KEYSER ESTATES SUBDIVISION

APPLICATION NUMBER 14 DATE June 5, 2008

REQUEST Subdivision

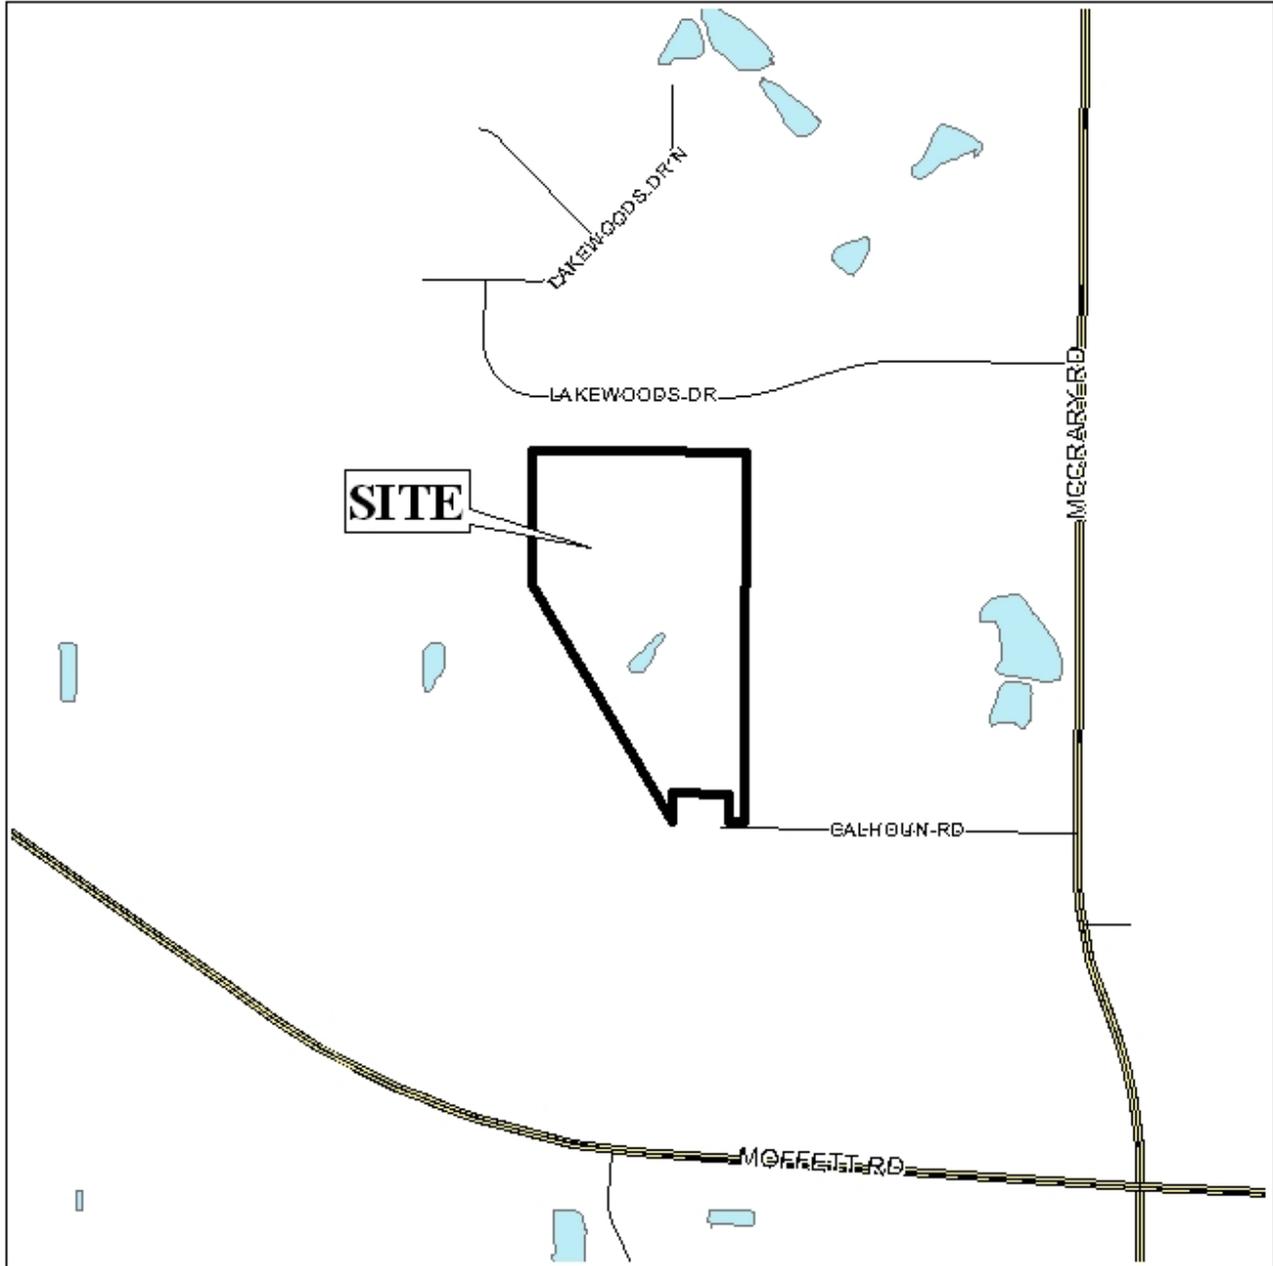
The plat proposes one flag shaped lot and one irregularly shaped lot. The Commission recently adopted an amendment to the Subdivision Regulations generally disallowing flag shaped lots. The applicant submitted no documentation to justify a waiver of Sections V.D.3 and V.D.1, nor is there an existing pattern of flag lots in the immediate vicinity.

Further, V.D.1 states that IF a flag shaped lot is allowed, and is large enough for future resubdivision, the pole shall be adequate to provide for a future dedicated and constructed street. As the site exists, there is 54.35' of frontage on Calhoun Road, which would barely be sufficient for a curb and gutter standard street. Therefore, dependent upon the purpose of the subdivision, the most appropriate consideration may be as a Family Subdivision to allow a private road in compliance with Section VIII.

Given the location of a lake or pond on the site, it would be considered environmentally sensitive; therefore, the approval of all applicable federal, state and local agencies would be required prior to the issuance of any permits or land disturbance activities. The flood zone(s) should be indicated on the plat, if approved.

Finally, if approved the plat should be revised to label each lot with its size in square feet.

Based on the preceding, the plat is recommended for holdover until the July 10 meeting to allow the applicant to:

1. revise the plat to provide either a private road for a family subdivision, or a dedicated and constructed road if the subdivision is not to be a family subdivision;
2. make appropriate notations on the plat relating to endangered species and environmental issues, as required by the Subdivision Regulations.
